WINTER GARDEN
CITY OF WINTER GARDEN
DEVELOPMENT REVIEW COMMITTEE
MINUTES
September 17, 2014

Agenda Item #3: Four Corners – UVPUD

Marsh Road - 17500

EXHIBIT A
 9-17-14 DRC MTG

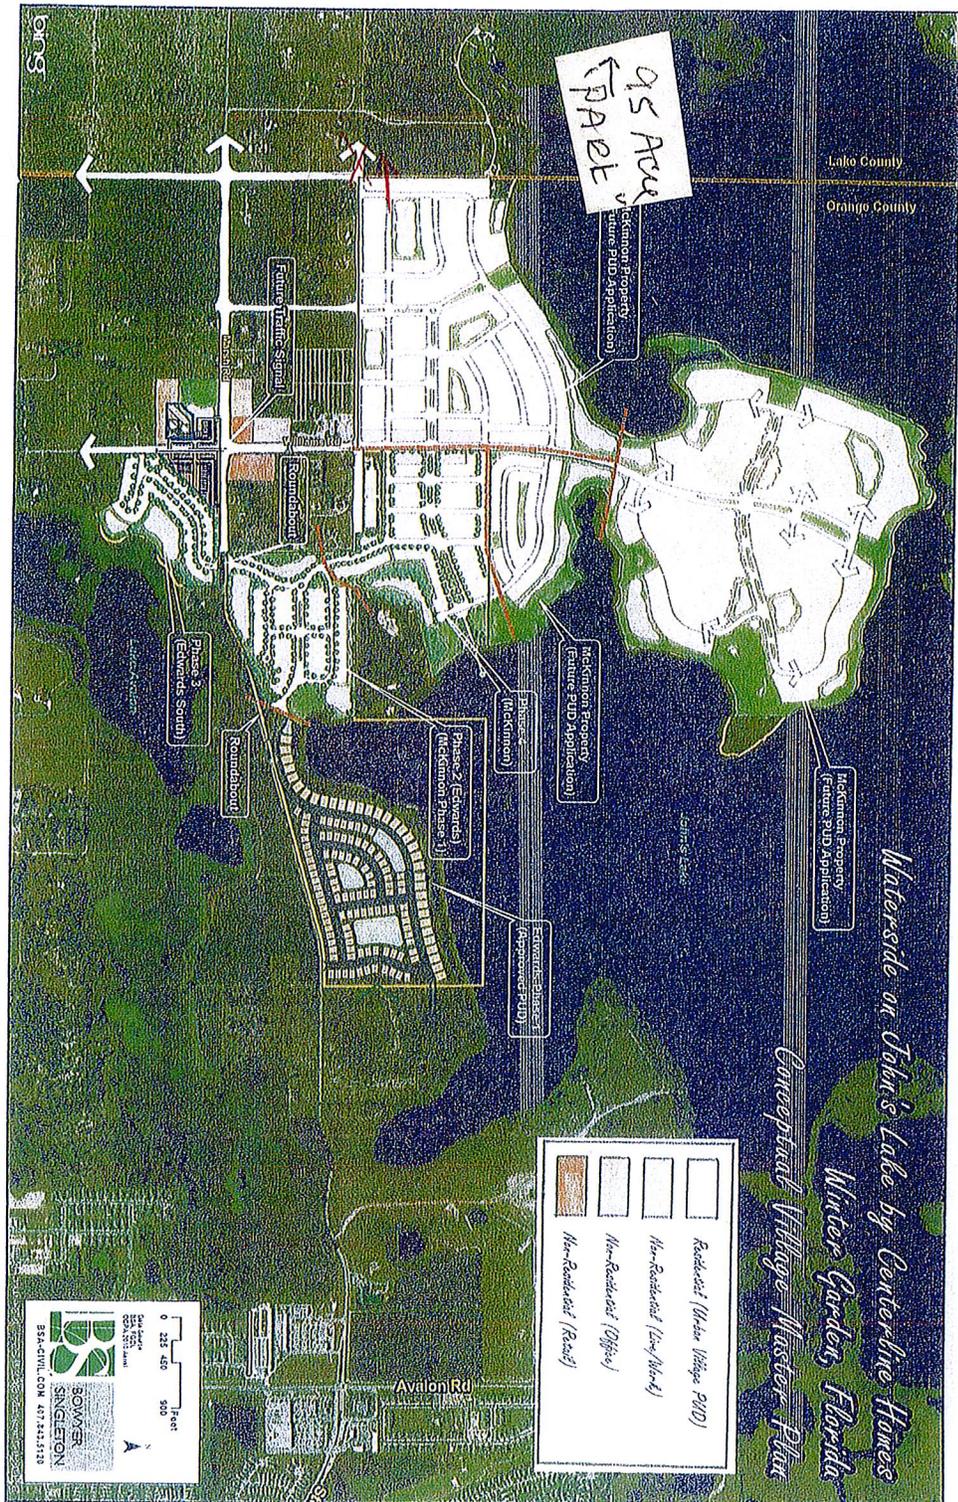
Applicant wished to discuss Conceptual Village Master Plan. Applicant submitted drawing for discussion – Exhibit A. This concept was reviewed.
